Certificate of Appropriateness Case Report

HEARING DATE: DECEMBER 19, 2012

Filing Date: April 13, 2006
Case No.: **2006.0494A**
Project Address: **2554 MISSION STREET (NEW MISSION THEATER)**
Historic Landmark: Landmark No. 245
Zoning: Mission St NCT (Neighborhood Commercial Transit) Zoning District
85-X Height and Bulk District
Block/Lot: 3616/007
Applicant: Andrew J. Junius, Reuben & Junius
One Bush Street, Ste. 600
San Francisco, CA 94104
Staff Contact Richard Sucre - (415) 575-9108
richard.sucre@sfgov.org
Reviewed By Timothy Frye – (415) 575-6822
tim.frye@sfgov.org

1 ENLARGED MEZZANINE BATHROOM PLAN
SCALE: 1/2" = 1'-0"

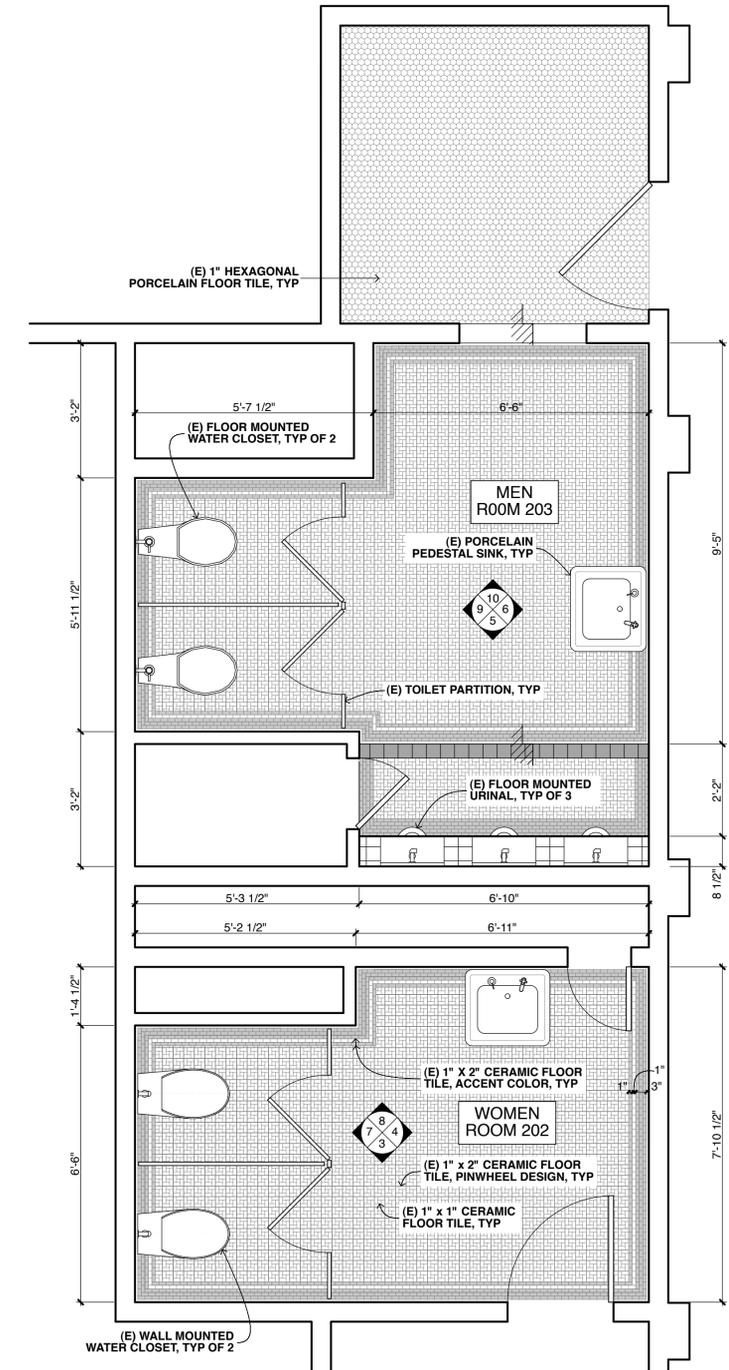
In response to comments from the Architectural Review Committee, the Project Sponsor has prepared documentation of the existing mezzanine restrooms. [See Drawing Sheet A-1.5]

The two mezzanine restrooms have been documented through photographs and annotated drawings and can be found on a new sheet, A1.5.

A-6.1

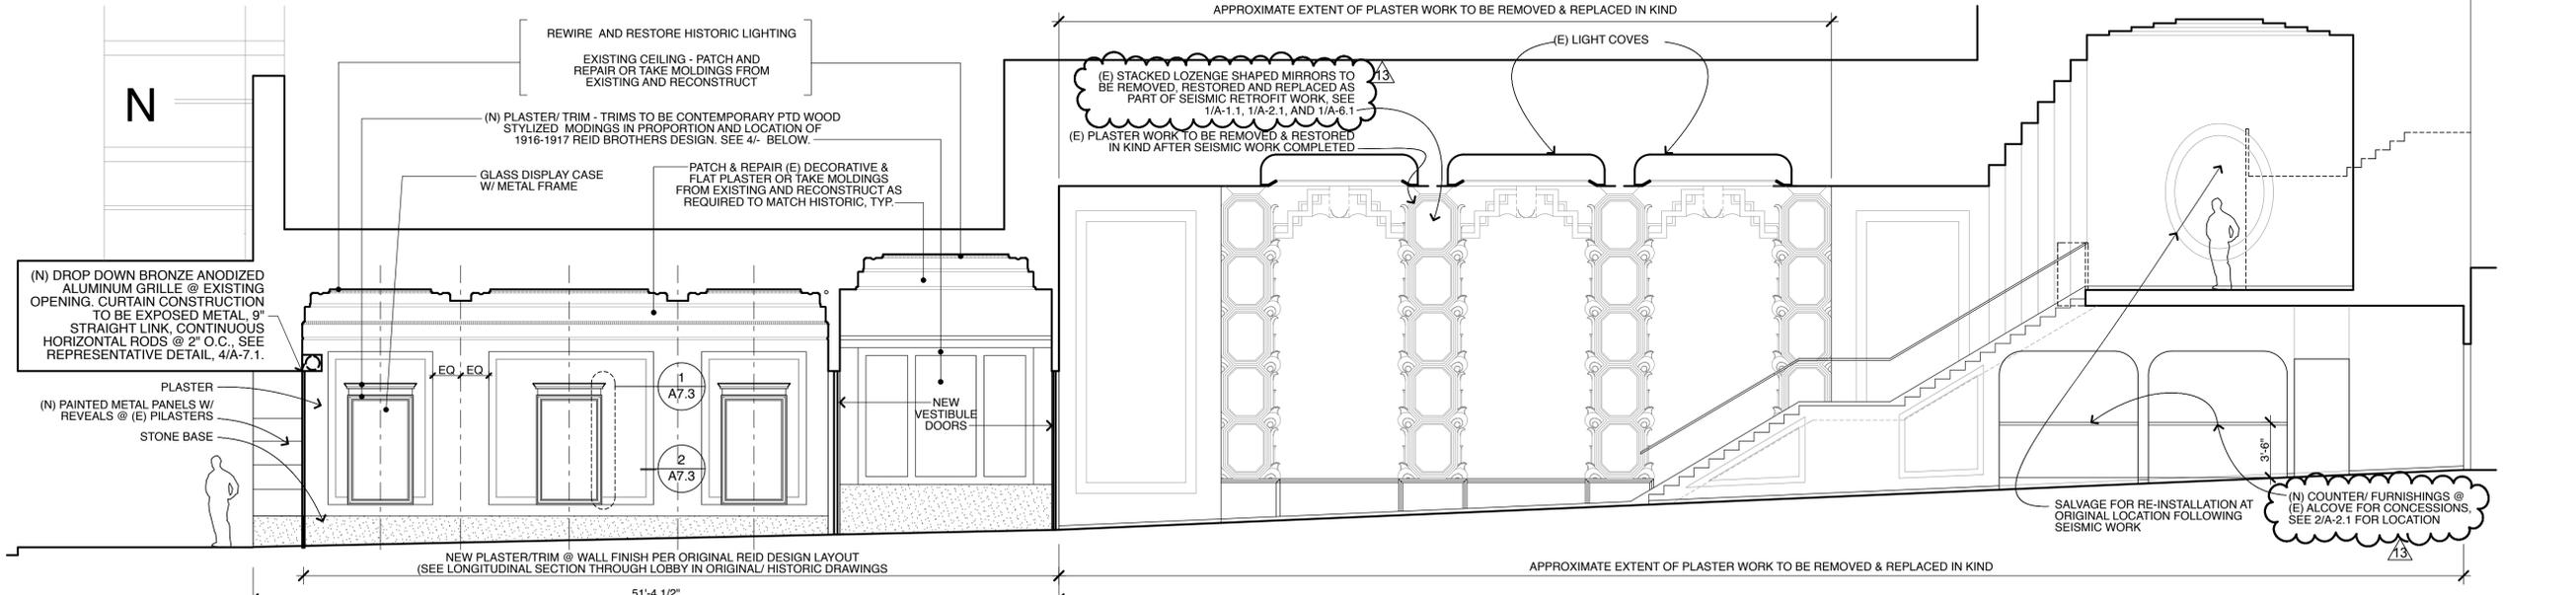
As noted above, the proposed project would remove the non-historic finishes within the vestibule, including the dropped acoustic ceiling tile and ceramic tile flooring, and would reconstruct the finishes and ceiling within the vestibule according to the 1916 design by the Reid Brothers. This reconstruction includes new plasterwork and trim based upon original historic drawings by the Reid Brothers. This reconstruction is undertaken with sufficient historical evidence, and would not impact any character-defining features of the New Mission Theater. Further, the new wood doors would be installed between the vestibule and promenade lobby. These new doors are designed to be historically appropriate, and are designed to be compatible and consistent with the architectural vocabulary of the interior. [See Drawing Sheet A-6.1]

A-6.4

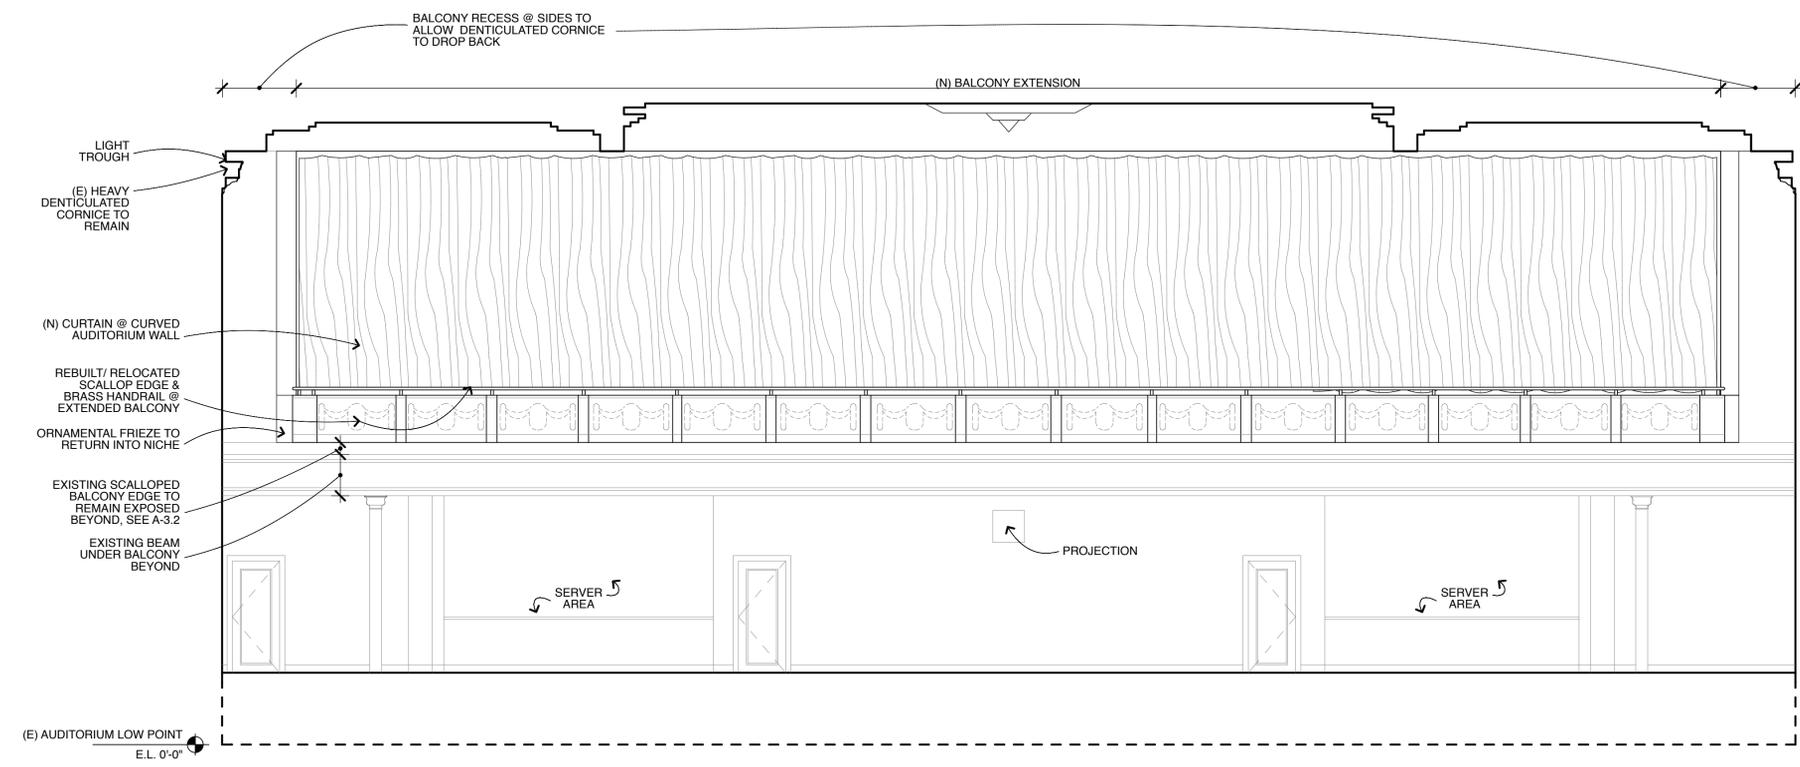
The proposed project would subdivide the main auditorium into five separate theaters: the main auditorium theater (Auditorium No. 1), three theaters within the lower balcony (Auditorium Nos. 2, 3, and 4), and a theater within the upper balcony (Auditorium No. 5). [See Drawing Sheets A-1.1, A-1.3, A-1.4, A-2.1, A-2.3, A-2.4, A-2.5, A-3.2, A-6.4, A-6.5, A-6.6, A-7.3]

4 DROP DOWN SECURITY GRILLE
SCALE: 1" = 1'-0"

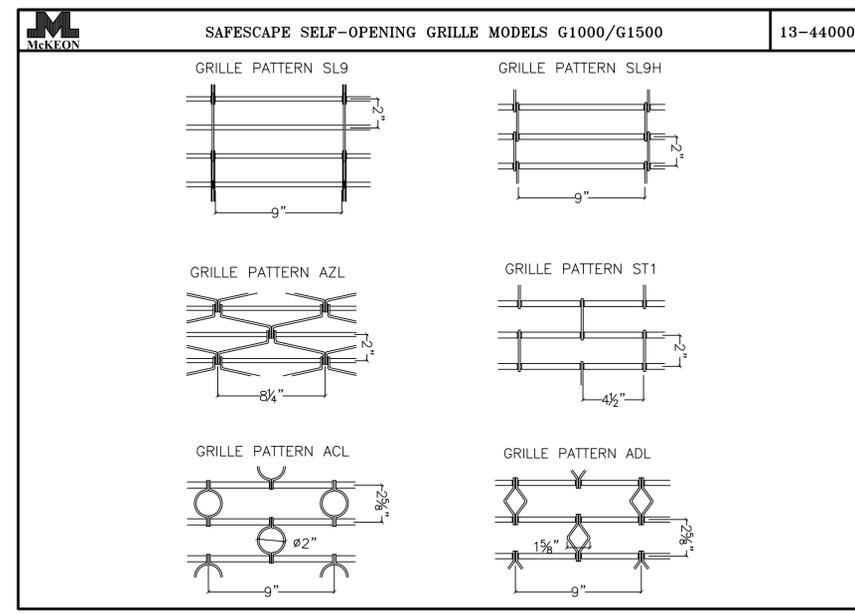
On the exterior, the only new exterior features will be a new metal security grille located along Mission Street. The new metal security grilles will consist of a drop down anodized aluminum grille. This new security grille would allow for visibility into the promenade lobby and would feature a compatible material and finish. Overall, the new security grille would not impact any character-defining features on the exterior, and would not detract from the theater's overall architectural feature. [See Drawing Sheets A-2.1, A-3.1, A-7.1,]

Both the Preservation Architect, Architectural Resources Group (ARG), and KMA have carefully considered this issue and believe it would be best to provide a security grille in a clear anodized aluminum finish and a pattern such as SL9 as shown on sheet A7.1. The long, parallel, horizontal lines are in keeping with traditional Art Deco proportions and shall not detract from the viewing of the historic interior by pedestrians on the street.

A-7.2

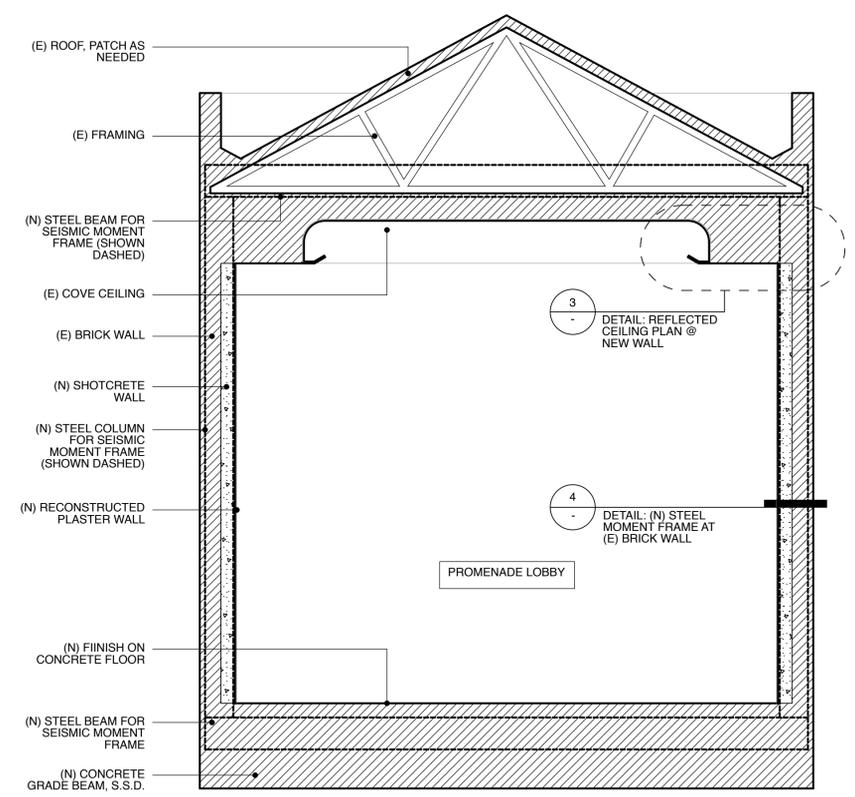
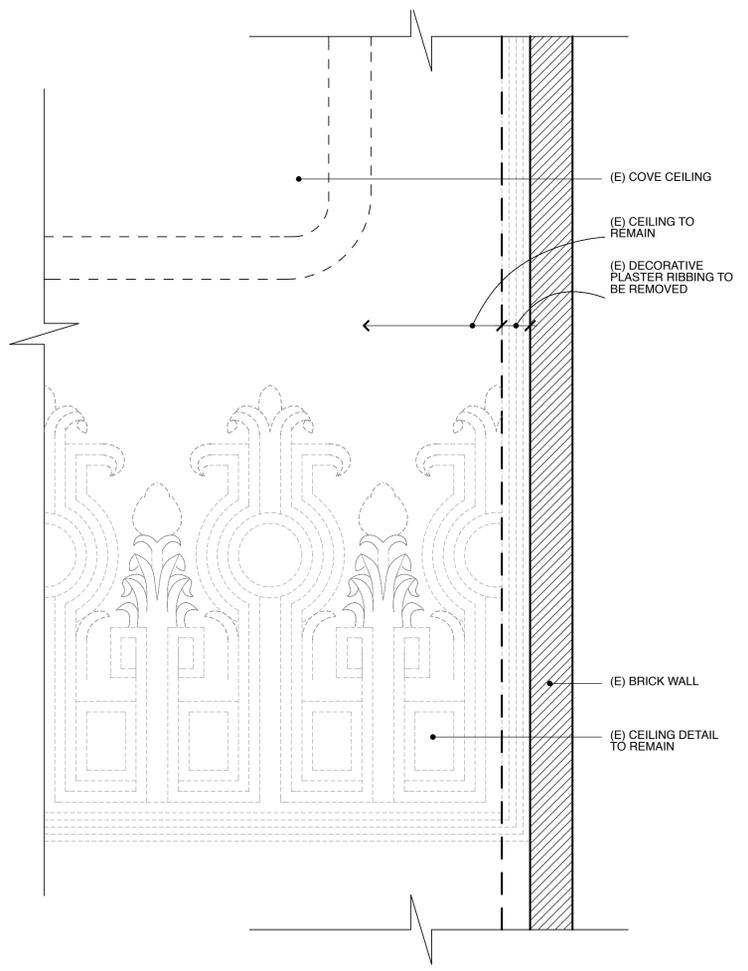
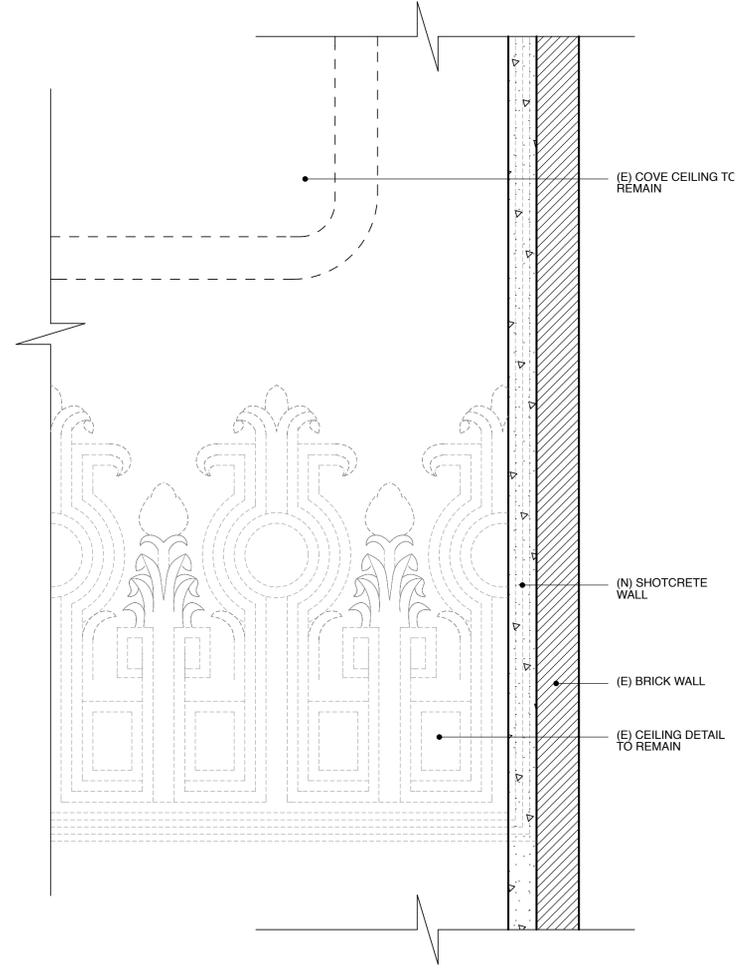
including the existing historic mirrors and ceiling. The Department recognizes the constraints entailed with the seismic upgrade of this feature and the efforts to achieve an appropriate restoration and reconstruction of these architectural features—many of which are severely deteriorated. This aspect of the project appears appropriate, since all of the historic decorative elements will be repaired, restored and/or reconstructed based upon photographic and documented physical evidence, including plaster molds and high resolution photography. [See Drawing Sheets A-1.1, A-1.2, A-1.4, A-6.1, A-7.2]
